**BLOOMINGTON PLAN COMMISSION  
STAFF REPORT**

**CASE #: PUD/DP-24-21  
DATE: February 6, 2023**

**Location: N. Prow Road; 3500 block of N. Hackberry Street**

**REQUEST:** The petitioner is requesting a final plan amendment and a primary plat amendment for Ridgefield PUD and Subdivision Section V.

GRIDFIELD SUBDIVISION  
SECTION V PHASE 2  
BLOOMINGTON, INDIANA  
FOR  
BOB SHAW  
BRCU Project No: 6015  
LANDSCAPE PLAN

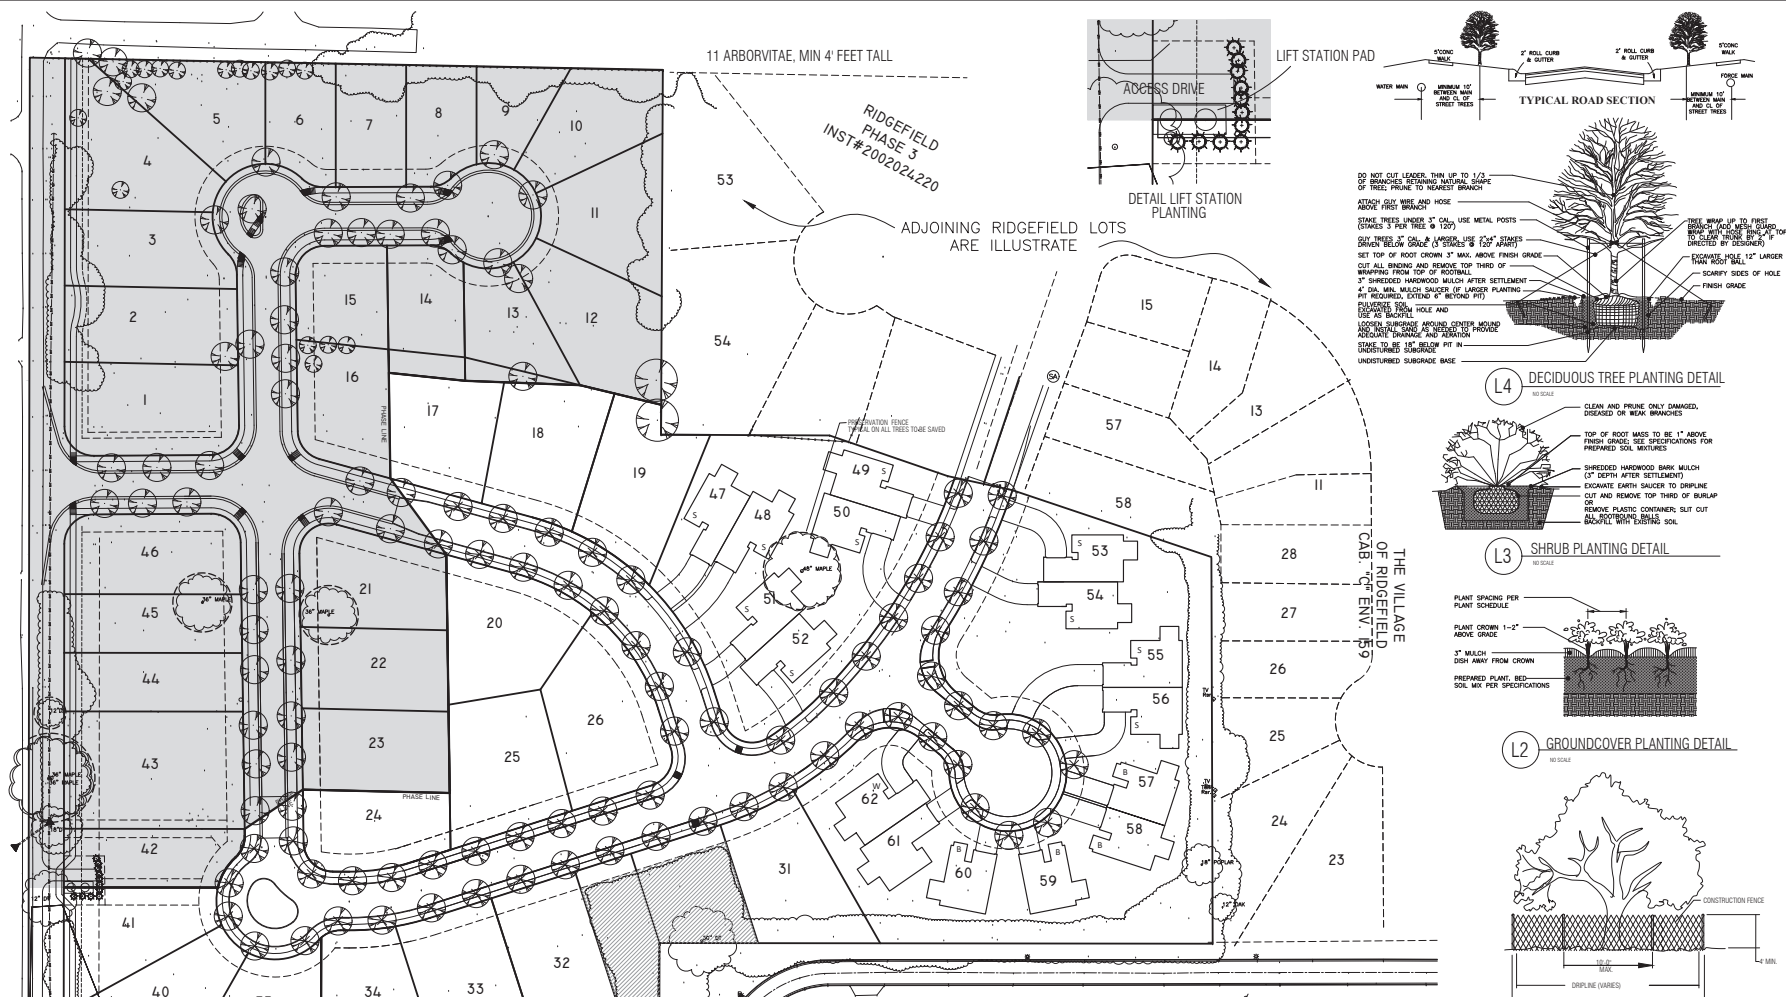
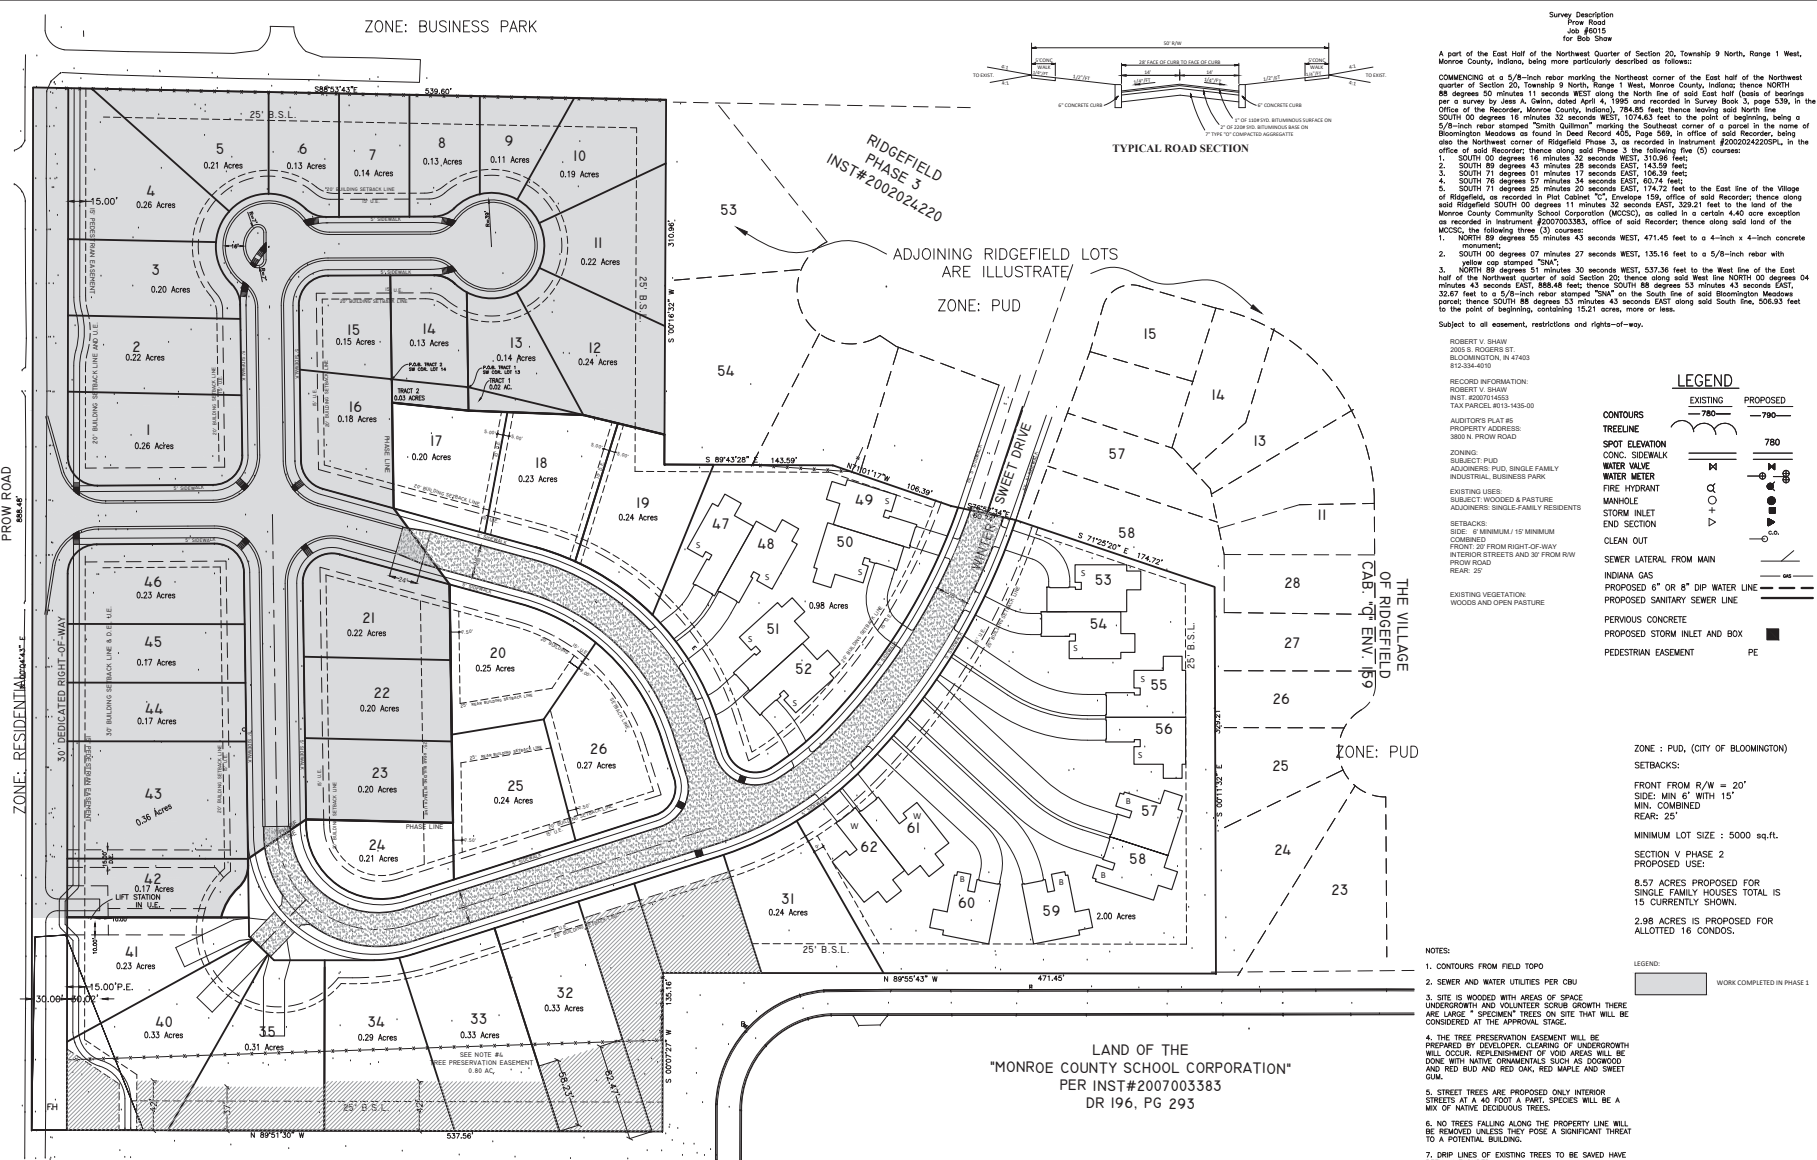
There were a number of other trees that were highlighted for preservation through the 2008 approval that have since been removed. Some are still shown on the landscape plan for this petition, but are on private property not owned by the petitioner. The Department requests an updated and accurate landscape plan to be submitted and approved by staff before the January hearing. ***The petitioner has submitted a new landscape plan.***

- ***The original plan showed 4 specimen trees in the undeveloped portion of Section V. Only one remains on the new landscape plan. If the others still exist, the Department recommends adding them back to the plan.***

- ***The tree buffer shown south and east of the paired homes has been removed. The Department recommends adding it back to the plan.***
  - ***The missing street trees in the developed portion of Section V are no longer shown. The Department recommends adding them back to the plan.***

- ***Proposed street trees along Prow Road are no longer shown. Existing street trees along Prow Road are no longer shown. Because subdivision requires one street tree for every 40 feet of linear frontage, the location of existing and proposed street trees need to be shown. The Department recommends adding them back to the plan.***

- ***Buffer yards on the rear of lots 7-12 that can no longer be confirmed, as they have been sold to private owners, were removed from the plan.***
  - ***The detention pond seed mix information and instructions need to be added to the plan.***

- All four specimen trees shown in the 2008 plans for the undeveloped portion of Section V need to be shown on the plan. If they have died, please submit proof to the Department.

- The tree buffer originally shown on the 2008 plans south and east of the paired homes needs to be added to the plan.
  - Missing street trees in the developed portion of Section V need to be added to the plan.

- Existing and proposed street trees along Prow Road, in order to meet one tree for every 40 linear feet of frontage, need to be added to the plan.
  - The landscape plan shall be updated to match the approved road design.

Original Layout

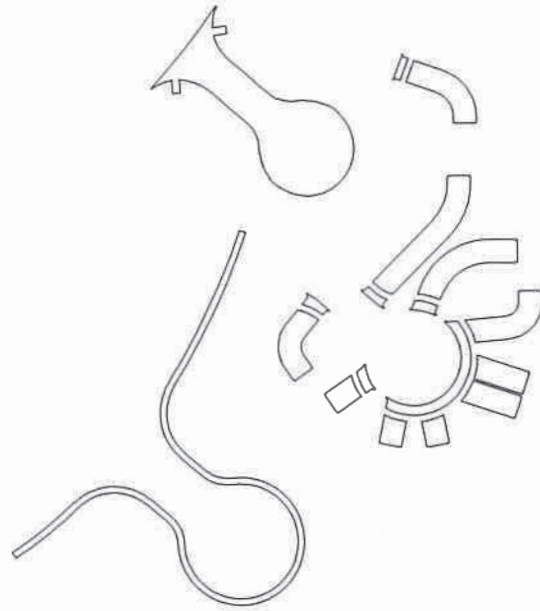
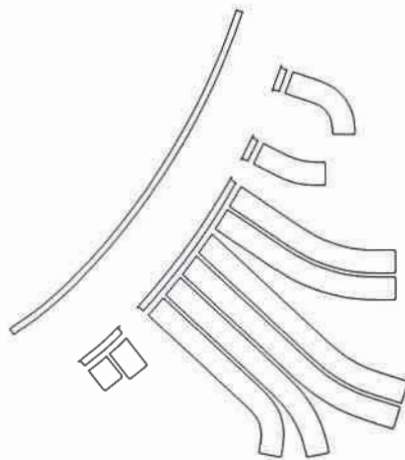
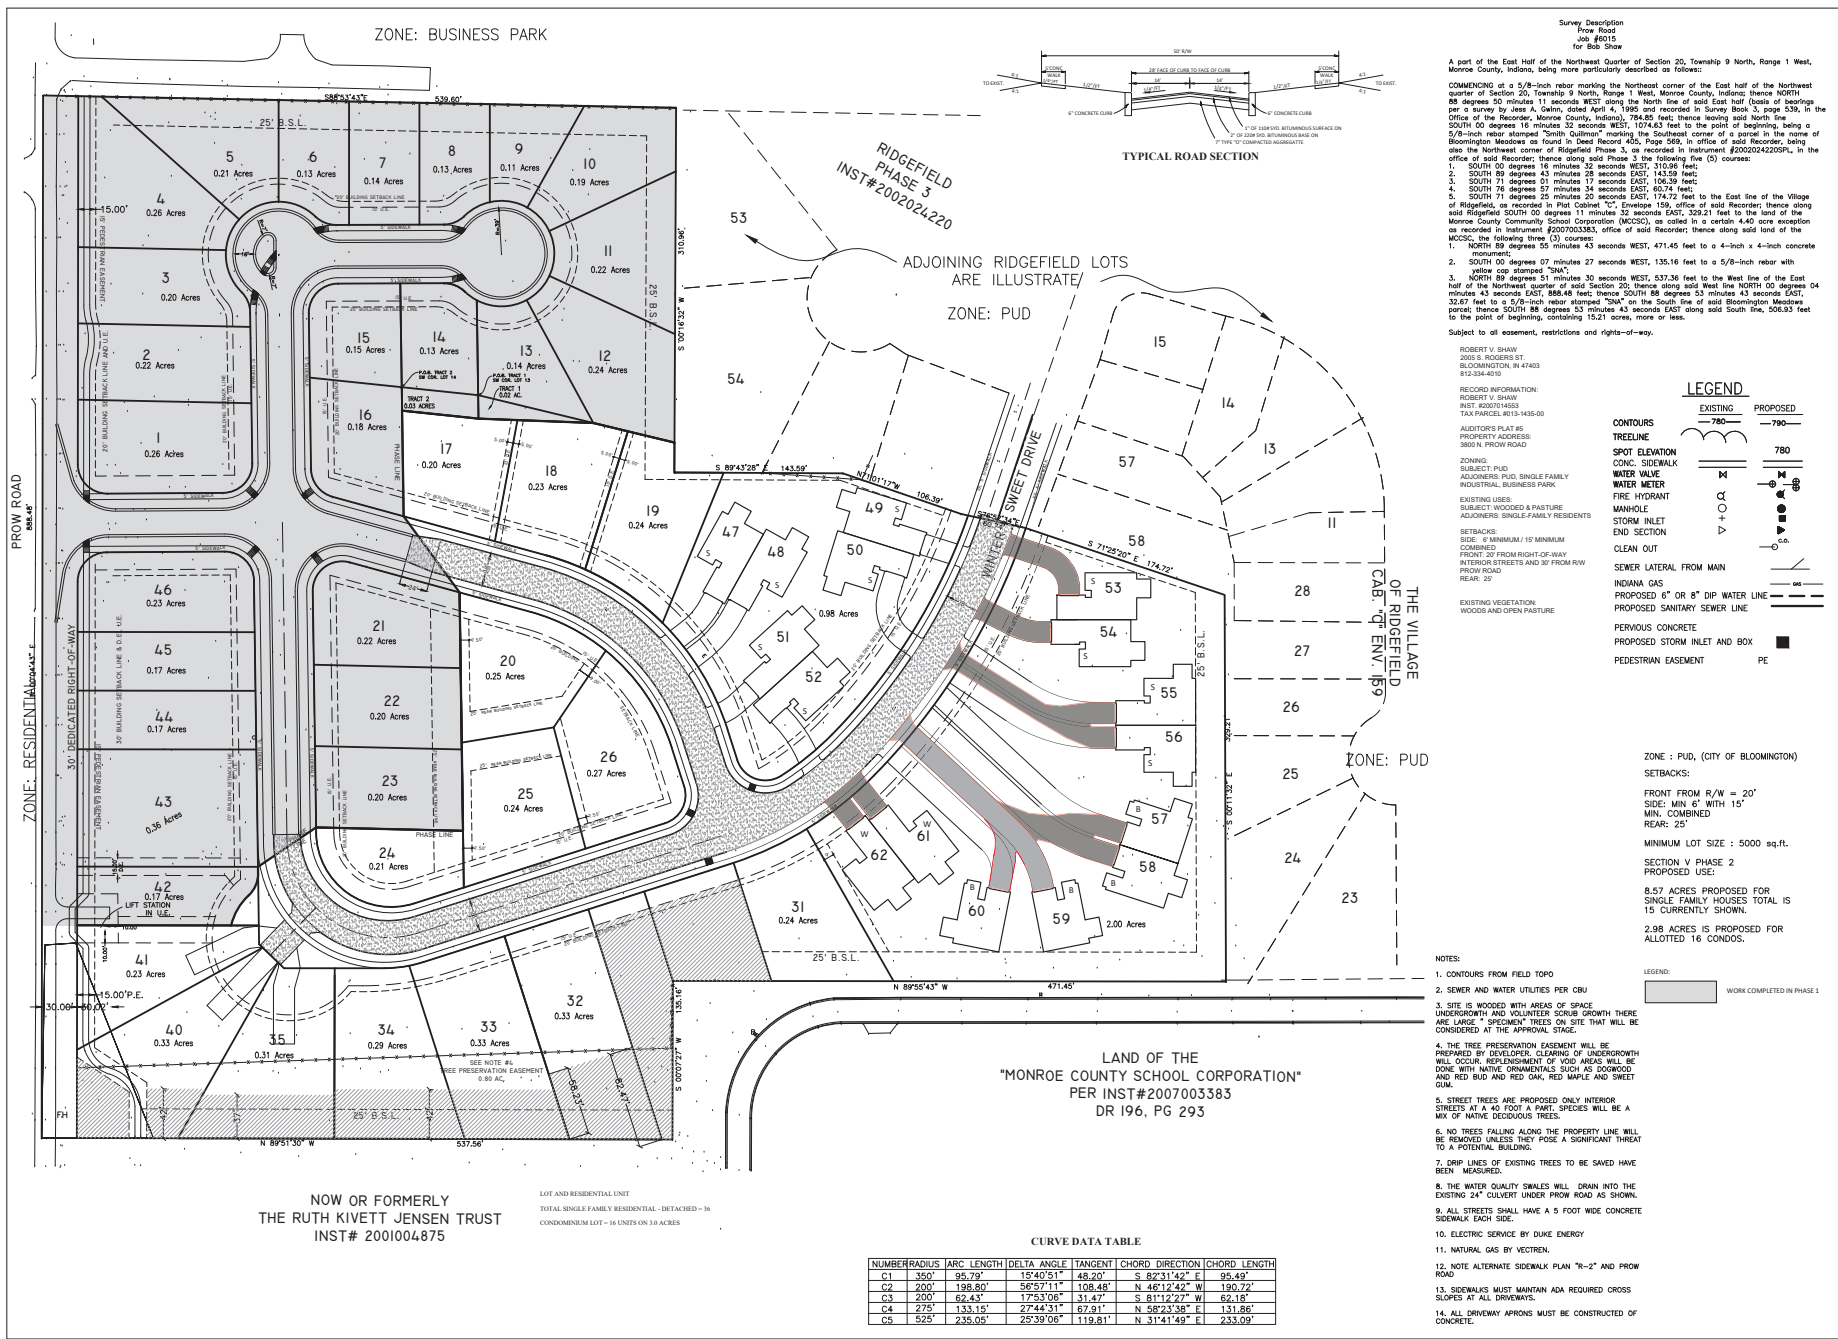
The UDO does not allow for culs-de-sac or eyebrow design. The petitioner proposes to leave both the eyebrow shown at the southwest portion of the development and the new cul-de-sac, Bradley Court, at the southeast portion of the development. The petitioner may be able to re-design the site to meet current code, but would like to utilize the previously approved design to maximize the number of parcels without a re-design. The Department recommends that the Plan Commission does not approve the design request, and asks for a re-design before the second required hearing in January. *After the December 2022 hearing, the petitioner has shown that a design is possible.* The roads in Section V are intended to be public, which means the maintenance responsibility will be the City’s once the roads are built to City standards. Cul-de-sac are difficult to clear of snow, as well as roads containing eyebrows. They also present connectivity issues for pedestrians. The

**PROPOSED FINDING:** The petitioner is requesting to waive the standard that prohibits eyebrow design in 20.05.050(j)(5)(N), as well as Table 05-5 that only allows cul-de-sac design in limited use for commercial/employment subdivisions. The petitioner received approval for a similar design in 2008, but did not finish construction. The petitioner has submitted a design that meets both the eyebrow and cul-de-sac limitations of the UDO, but prefers to request the waiver. The Department recommends denial of the waiver request.
